HISTORIC DISTRICT COMMISSION NOTICE OF DENIAL

Application Number: HDC2025-00068

APPLICANT & PROPERTY INFORMATION						
NAME: Timothy Flintoff Jr.		COMPANY NAME: 4545 Architecture				
ADDRESS: 2761 E. Jefferson Ave, Ste 302	fferson Ave, Ste 302 CITY: Detroit STATE: MI ZIP: 48207					
PROJECT ADDRESS: 708 PALLISTER						
HISTORIC DISTRICT: New Center Area						
SCOPE:						
Rooftop dormer addition and replacement of original wir						
At the Regular Meeting that was held on 04/09/25 above-referenced application. Pursuant to Section		troit Historic District 9(1) of the Michigan

2 A4.1 DORMER FRAMING SECTION SCALE: 1/2" = 1'-0"

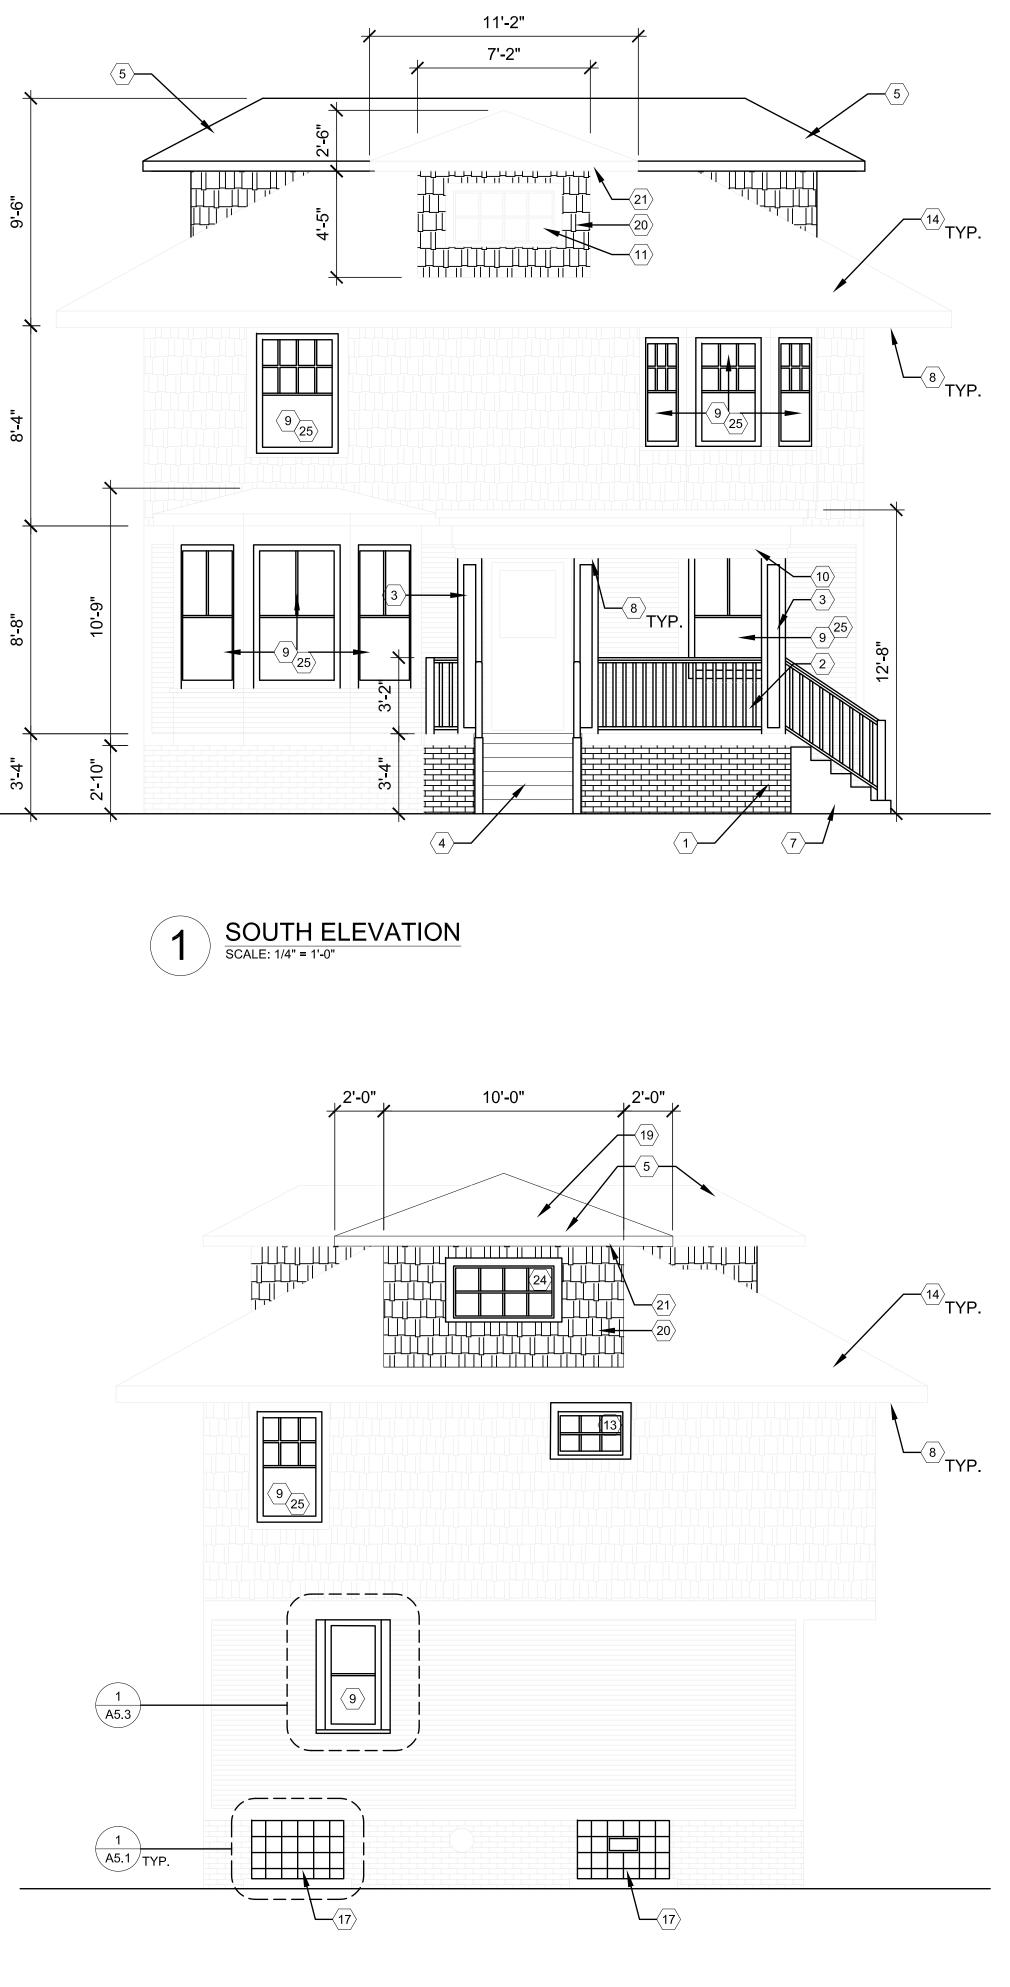
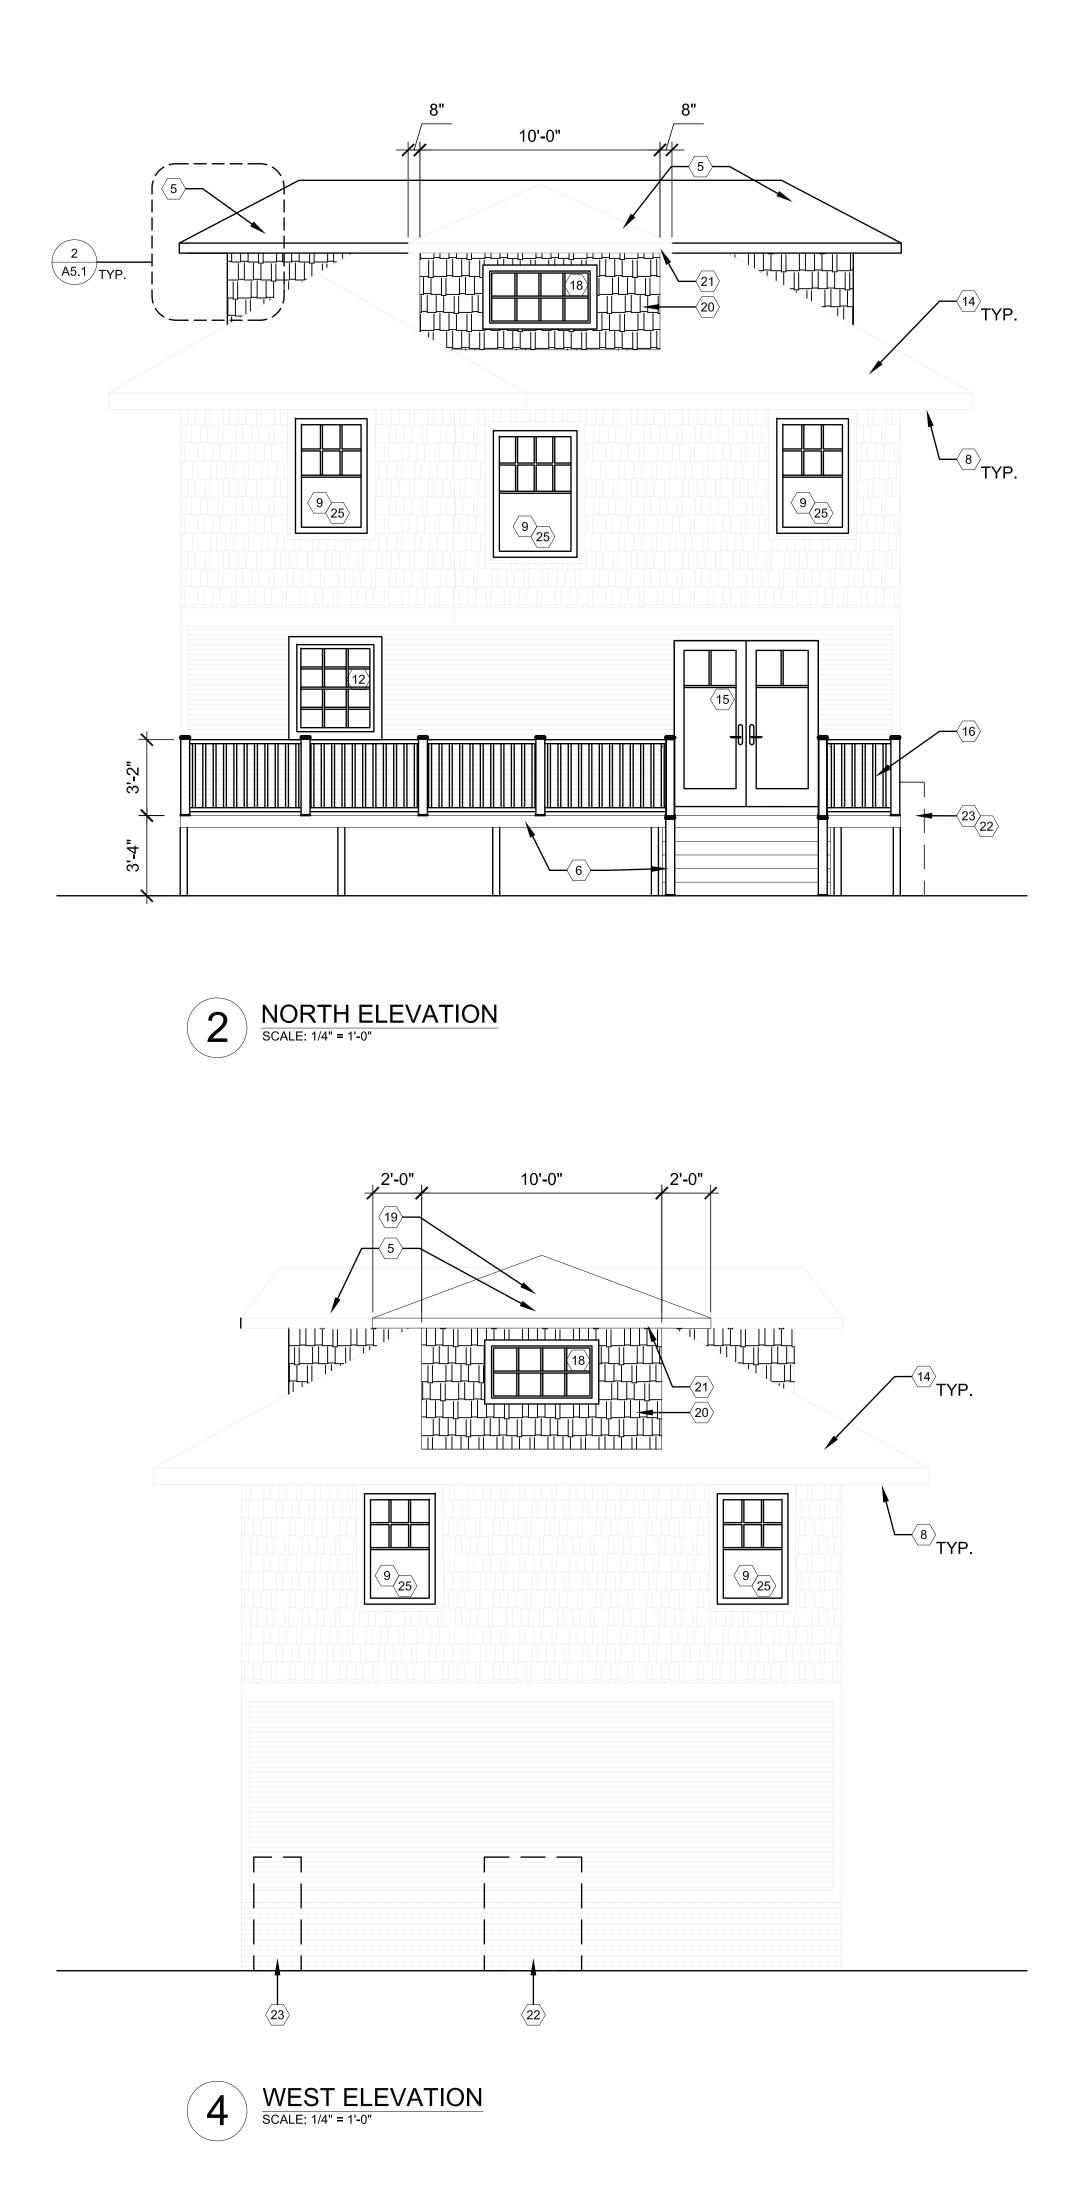
• The proposed rooftop addition, or "dormer complex" consisting of large east-west dormers joined together at a higher roofline, is incompatible with the historic scale and massing of the house and its block context, despite the effort to make them more compatible by improving materials and roof forms. They should instead be rebuilt in the smaller, narrower form of the precedent historic front dormer, as the original approved design prescribed, or removed altogether, restoring the original roof.

A3.1

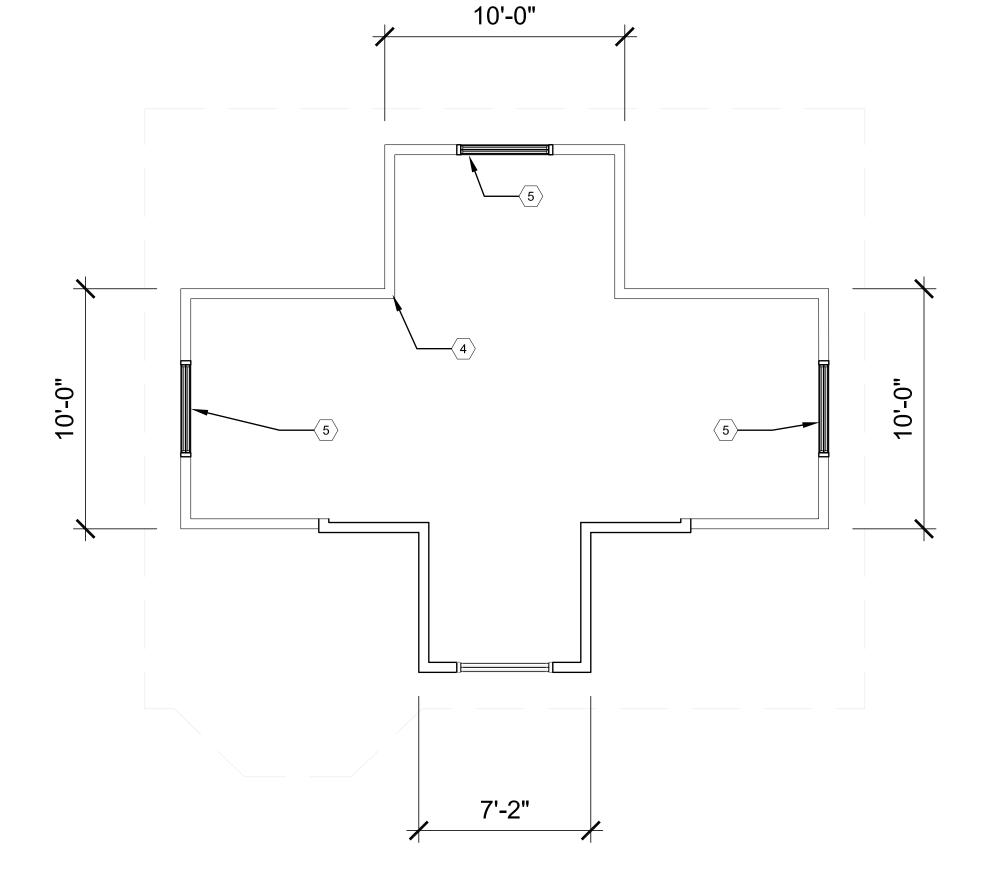
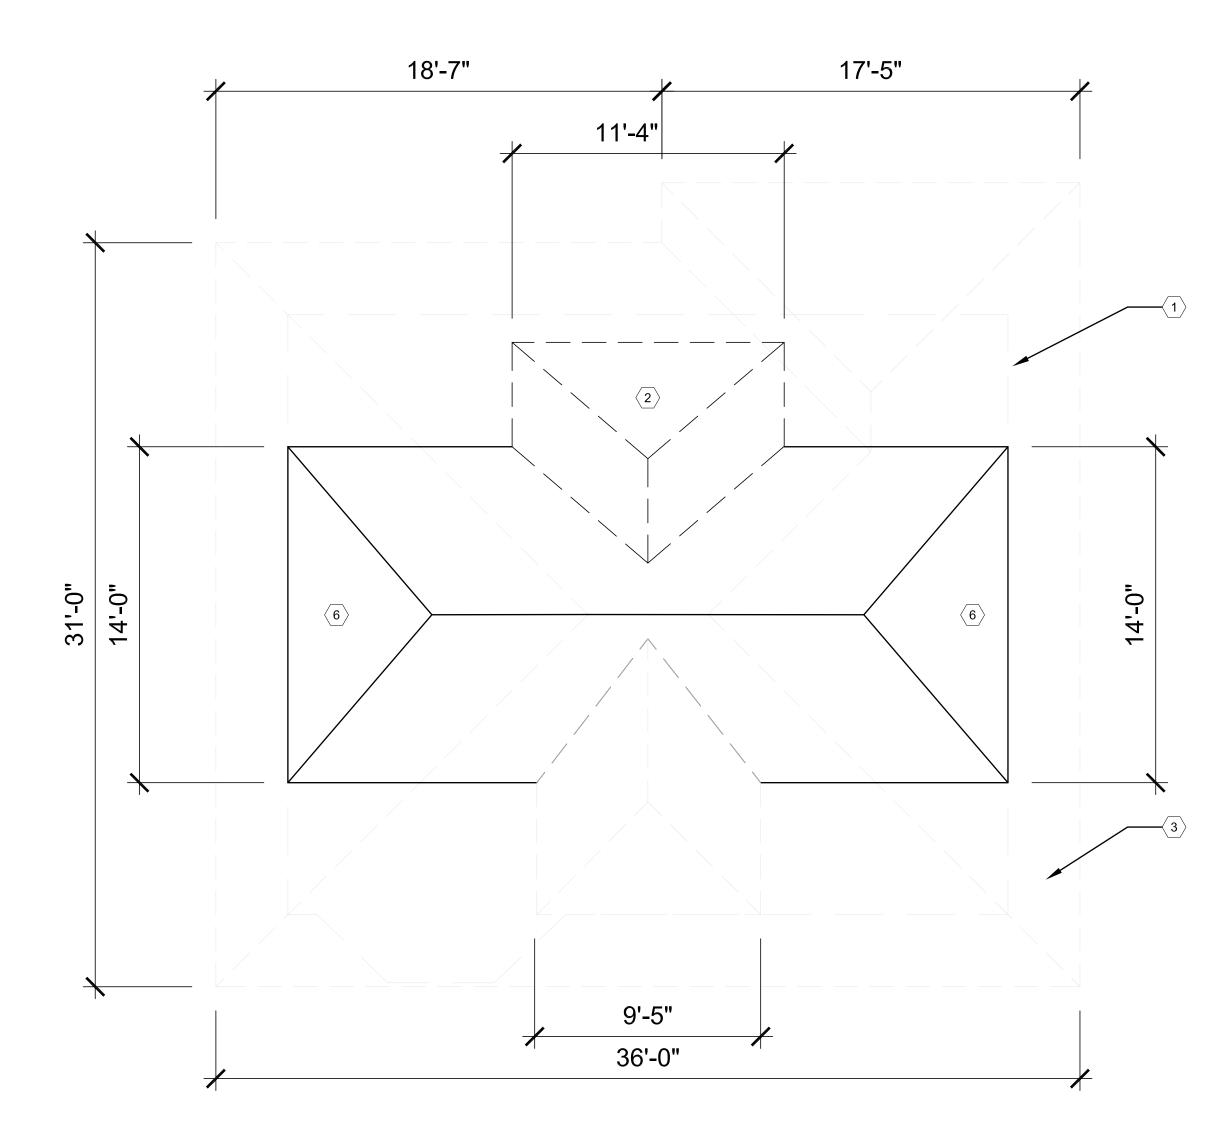
• The original 2/1 and multi-lite wooden windows were historic and distinctive character-defining features of the property, a key feature of the originally proposed rehabilitation design, and should be reproduced and restored.
